# **Amended Record of Decision**

**VanDerHorst Plant No. 1 Site  
City of Olean, Cattaraugus County  
Site Number 9-05-008**

**April 1996**

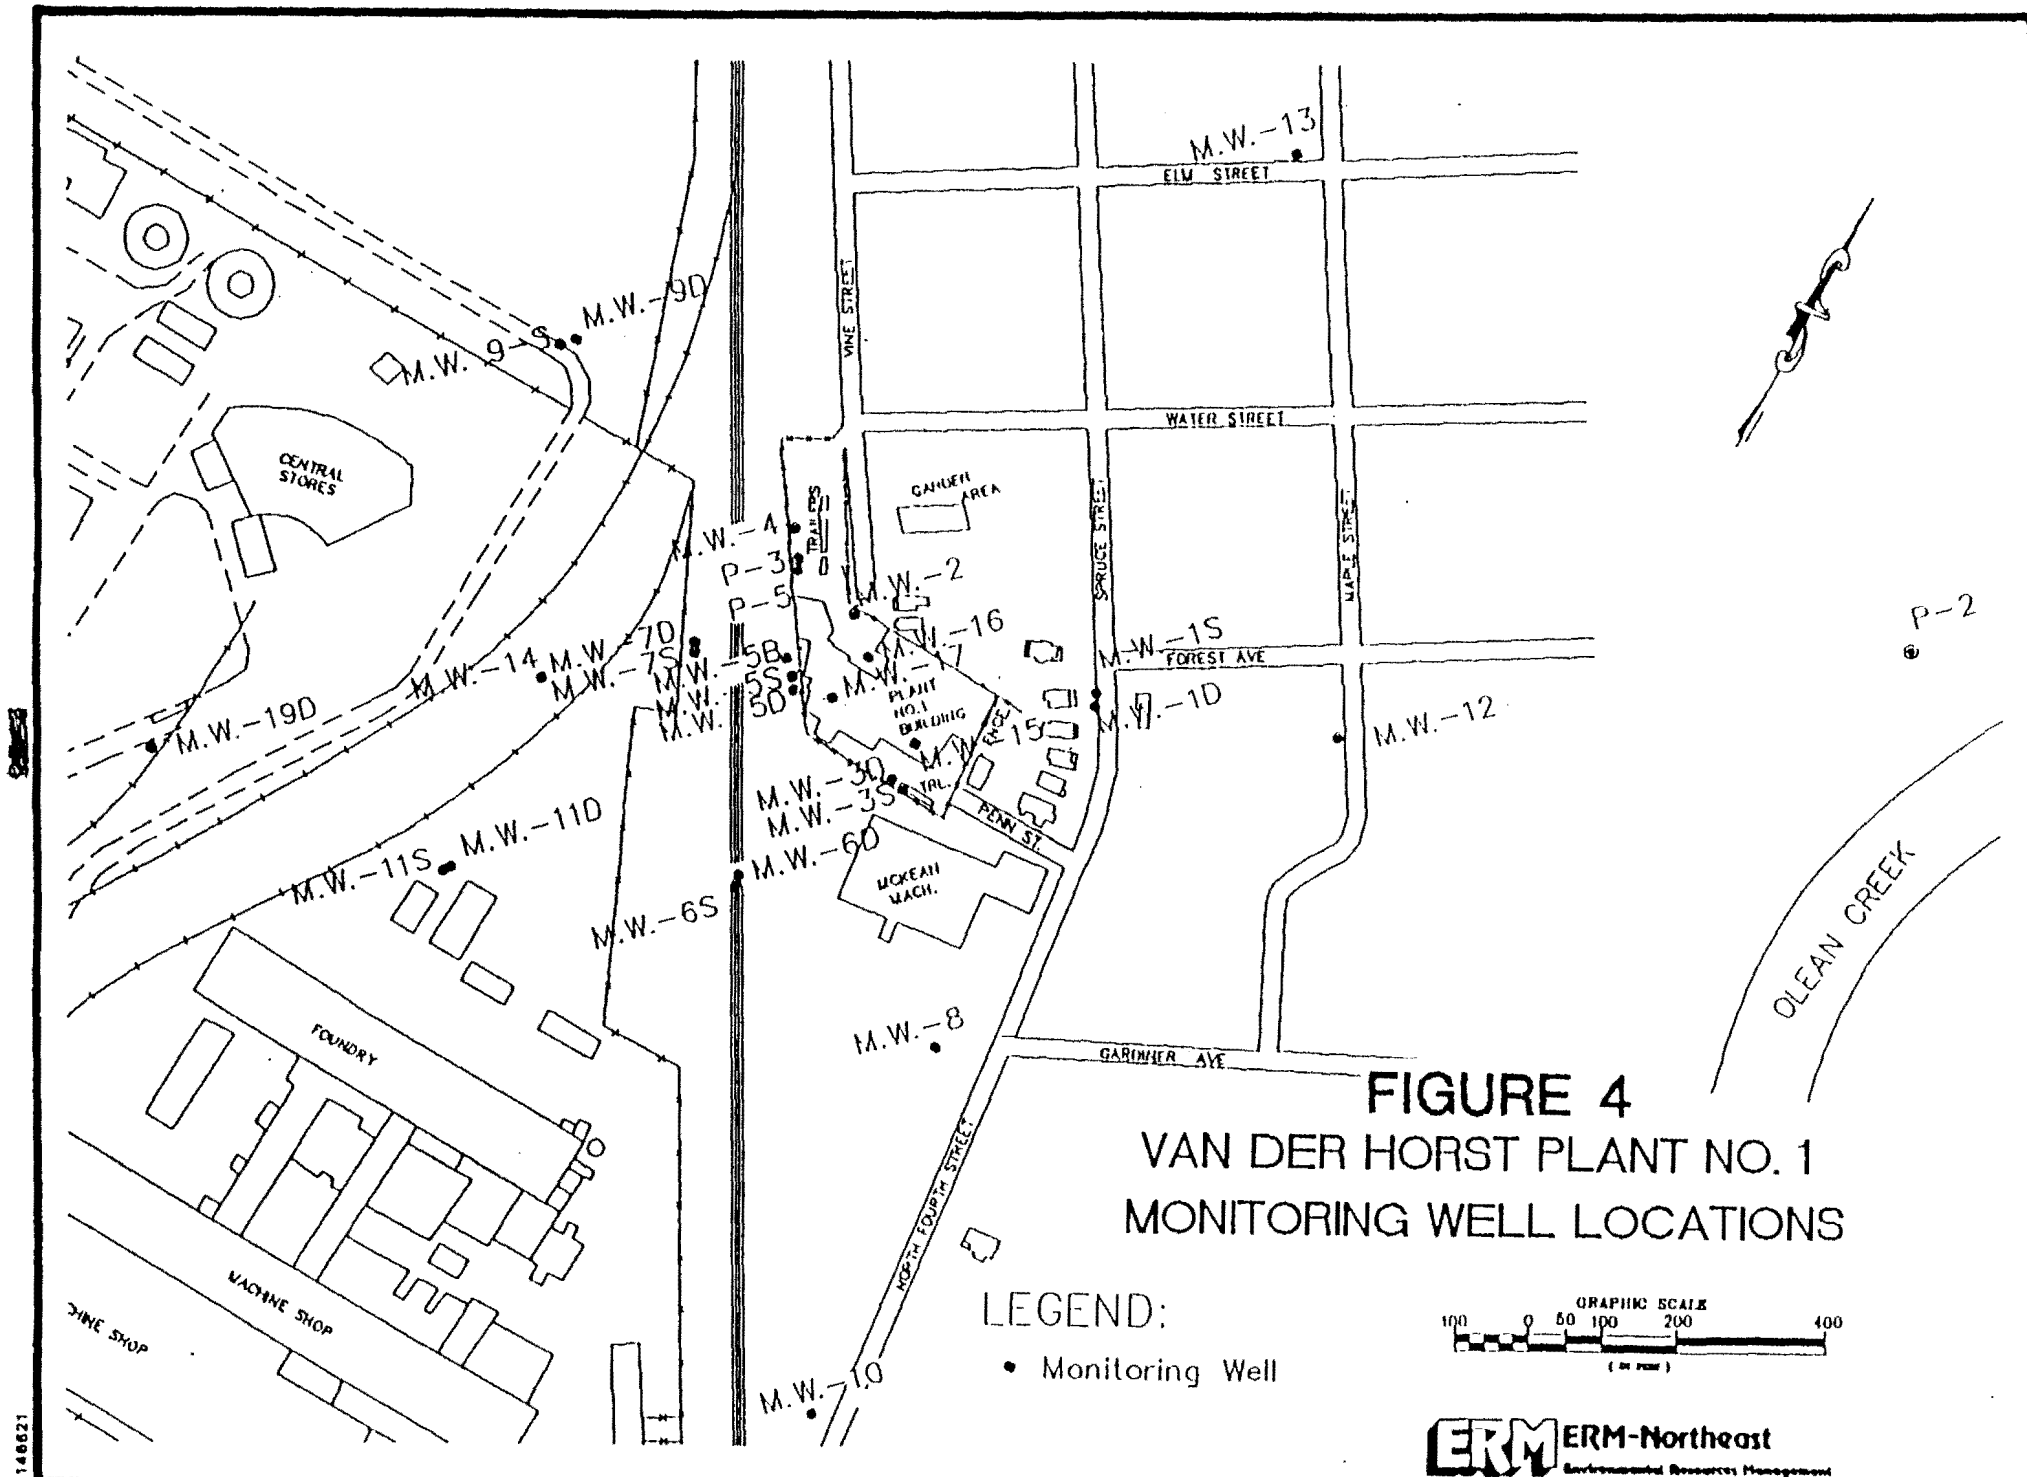
1. Soils targeted for remediation (approximately 9,000 cu. yds.) will be excavated and disposed off-site at an authorized disposal facility. Soils will not be treated and left on site. Based upon soil data obtained after the 1992 ROD, specific areas and volumes of soil have been targeted for removal. This amendment includes the removal of essentially all site soils to a depth of two feet and deeper in several areas where significant levels of contamination extend below that depth. The deepest excavation will be approximately 20 feet. To maintain a protective position regarding future threats to groundwater, deeper soils considered significantly contaminated (i.e., greater than 500 ppm chromium) were included in the estimate. Off site, all contaminated soils above the original cleanup goal of 50 ppm will be removed. Figure 6 shows the extent

of the soil removal proposed. All excavated soil will be replaced with clean soil and the surface will be graded and revegetated. Figure 7 shows the final grading plan.
